**PLANNING COMMISSION REPORT
NON-PUBLIC HEARING ITEM
REGULAR AGENDA
PUBLIC HEARING ON THE VARIANCE ONLY**

PC Staff Report
2/27/12

ITEM NO 1b: PRELIMINARY PLAT; FAIRFIELD FARMS; 25TH TERRACE & O'CONNELL RD (SLD)

PP-12-15-11: Consider a Preliminary Plat for Fairfield Farms East Addition 1, located southeast of 25th Terrace & O'Connell Road. This request includes a variance request from the Subdivision design Regulations, specifically 20-811(c) regarding the provision of sidewalks on both sides of a street. Submitted by Johnson Group, LLC, for Fairfield Investors, property owner of record

Existing and Proposed Intersection Locations.

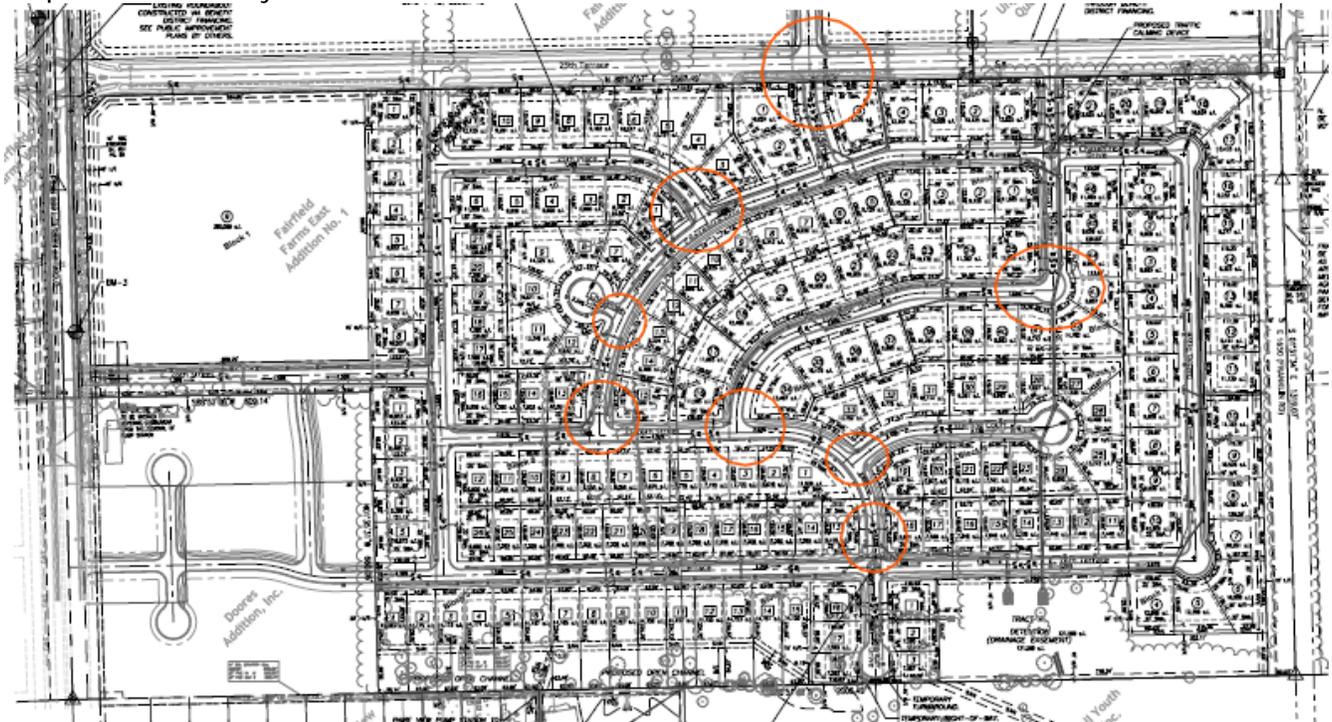
Three intersections with E 25th Terrace are included. The existing center off-set intersection (Fairfield Street) is realigned to create a 4-way intersection in this proposal. A key consideration of the subdivision design is the provision of internal connectivity between blocks within the development. City staff has indicated that 4-way intersections may require additional intersection treatment in residential development to keep traffic speeds low and reduce conflicts and protect pedestrian crossings. Additional intersection control at the intersection of 25th Terrace and Fairfield Street may be recommended with the Final Plat to be included with the public improvement plans.
